**Wet Limestone Based FGD System Package for DCRTPP, Yamuna Nagar
(2x300 MW)**

FLUE GAS DESULPHURISATION (FGD) SYSTEM PACKAGE
FOR
DCRTPP YAMUNA NAGAR (2X300 MW)
BIDDING DOCUMENT NO.: 4/CE/PLG/NTPC/DCRTPP/FGD-251
AMENDMENT NO. 4/CE/PLG/NTPC/DCRTPP/FGD-251-Amdt-01

FLUE GAS DESULPHURISATION (FGD) SYSTEM PACKAGE
FOR
DCRTPP YAMUNA NAGAR (2X300 MW)
BIDDING DOCUMENT NO.: 4/CE/PLG/NTPC/DCRTPP/FGD-251
Clarification No.-01

Pattern of stone columns (Typ)

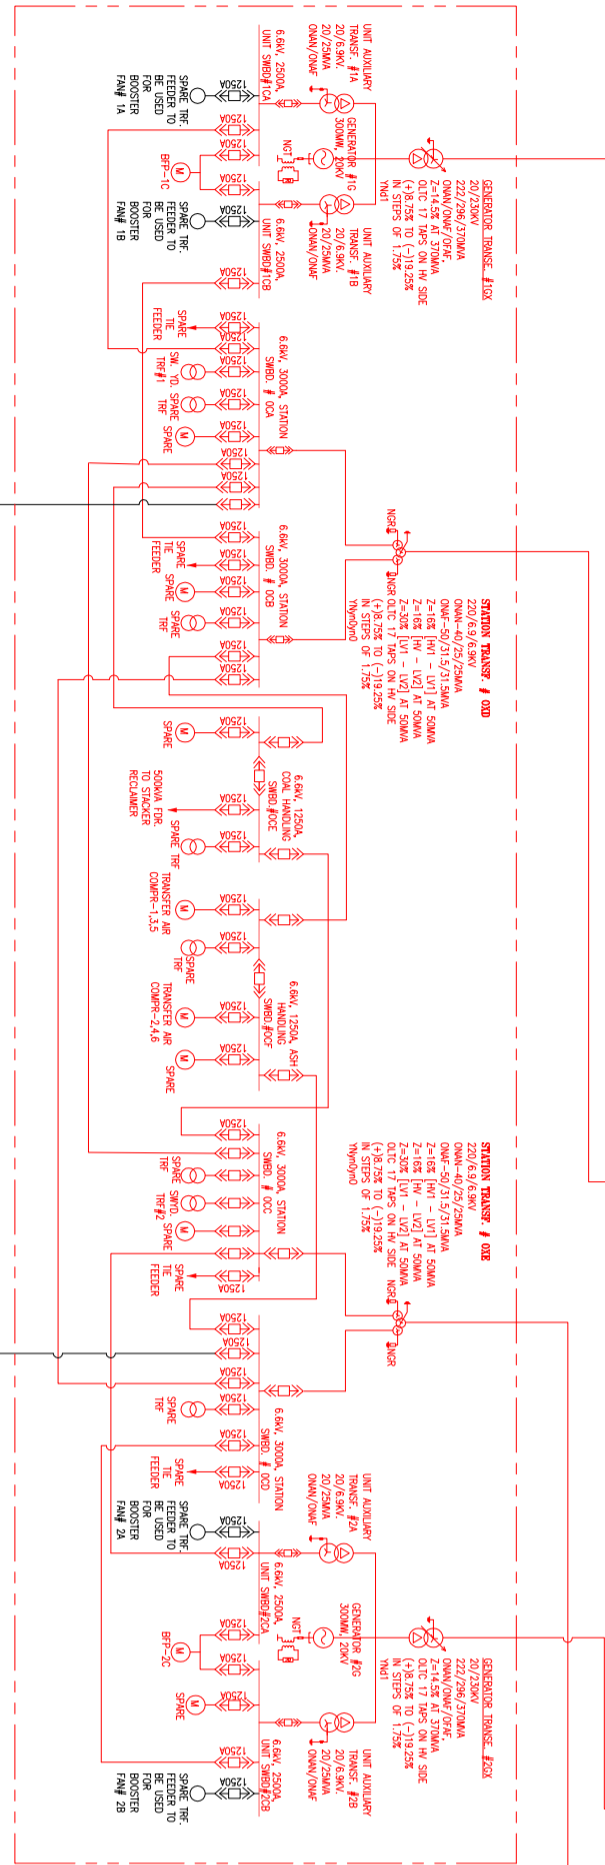
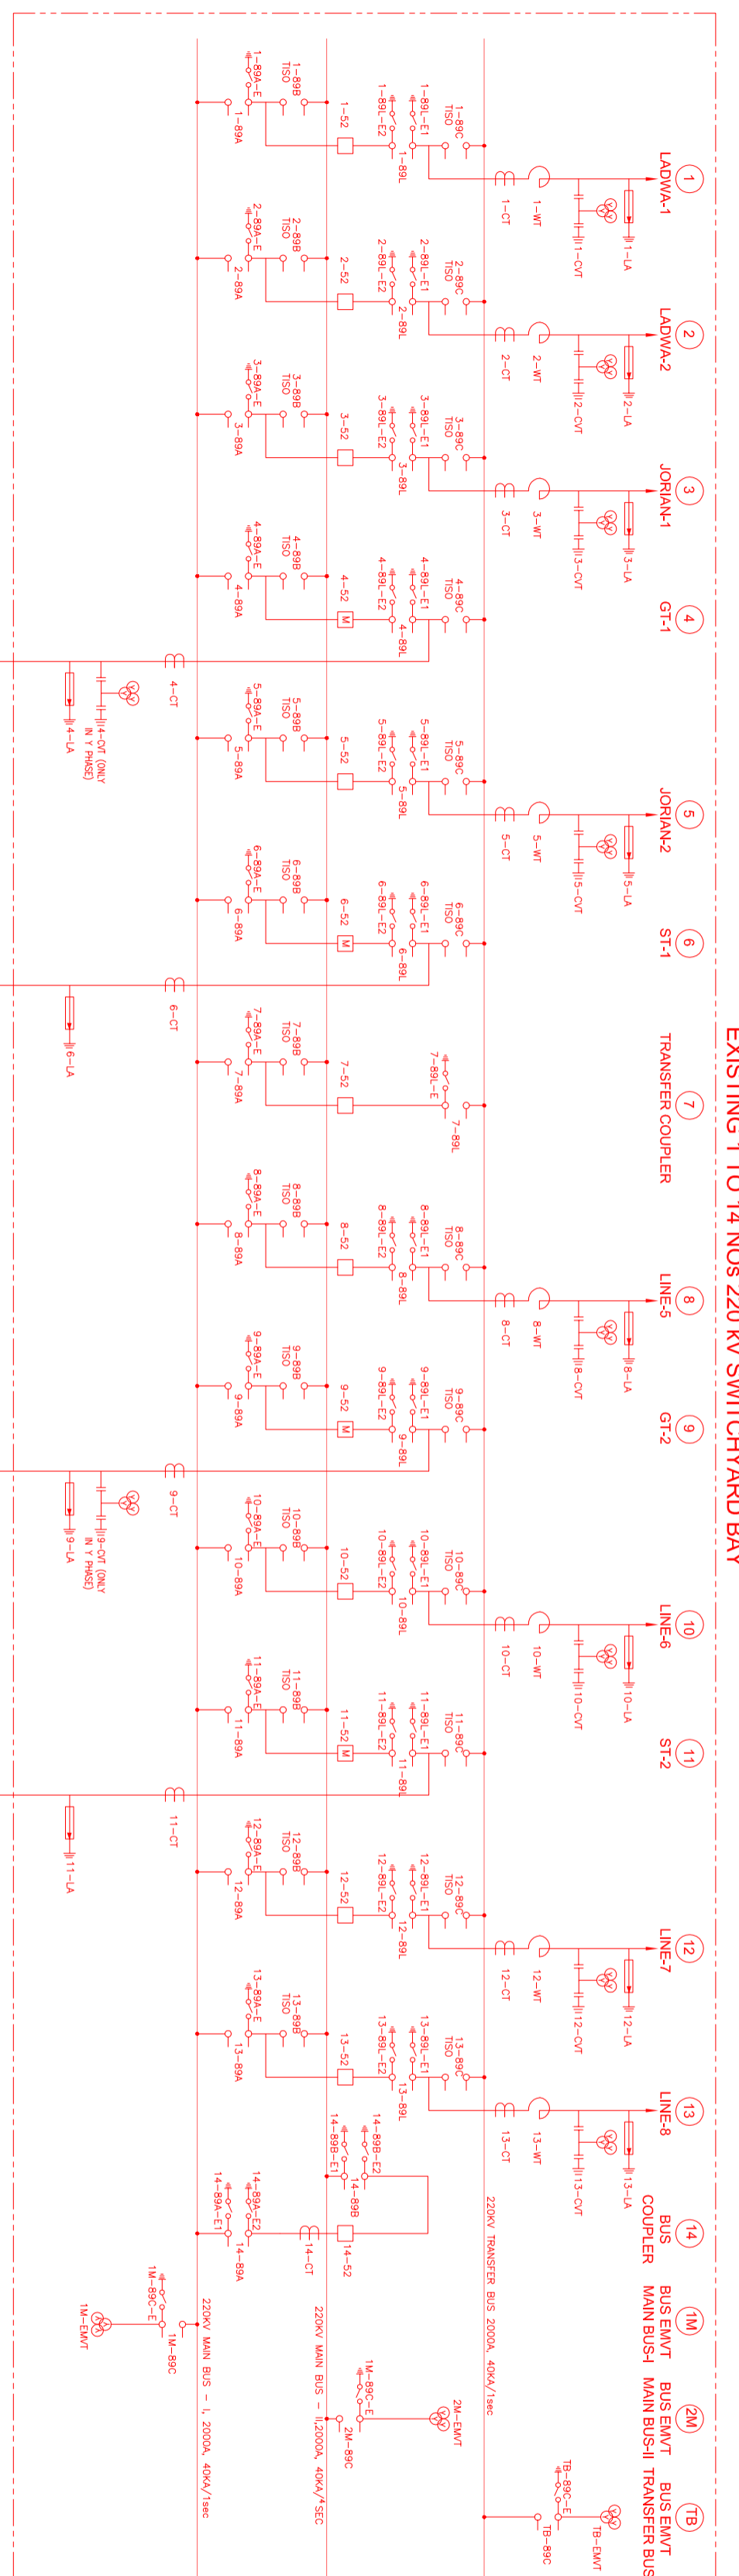
S. NO.	SPECIFICATION REFERENCE				EXISTING	READ AS
	SEC/PART	SUBSE C.	PAGE NO.	CLAUSE NO.		
SG						
1.	SECTION – VI, PART-A	II	24 OF 24	Table 1 to 5 (NEW CLAUSE)		Appendix-A added.
CIVIL						
2.	SECTION – VI, PART-A	II	7 OF 4	7.02.04(iii) (Appendix-B of AMENDMENT-2 to Technical Specifications Corrigendum-1 dated 25.07.19)	Ground improvement without piling provision after it Dia of column (d) = 900mm Spacing = 2.5m (Triangular pattern) Depth of ground improvement = 7m	Case:1 Ground improvement without piling provision after it Dia of column (d) = 900mm Spacing = 2.5m (Triangular pattern) Depth of ground improvement (d) = 7m Case:2 Ground improvement with piling provision after it Dia of column (d) =600mm/760mm/900mm Spacing = 2.5d to 3d (Triangular pattern) Depth of ground improvement (d) = 7m
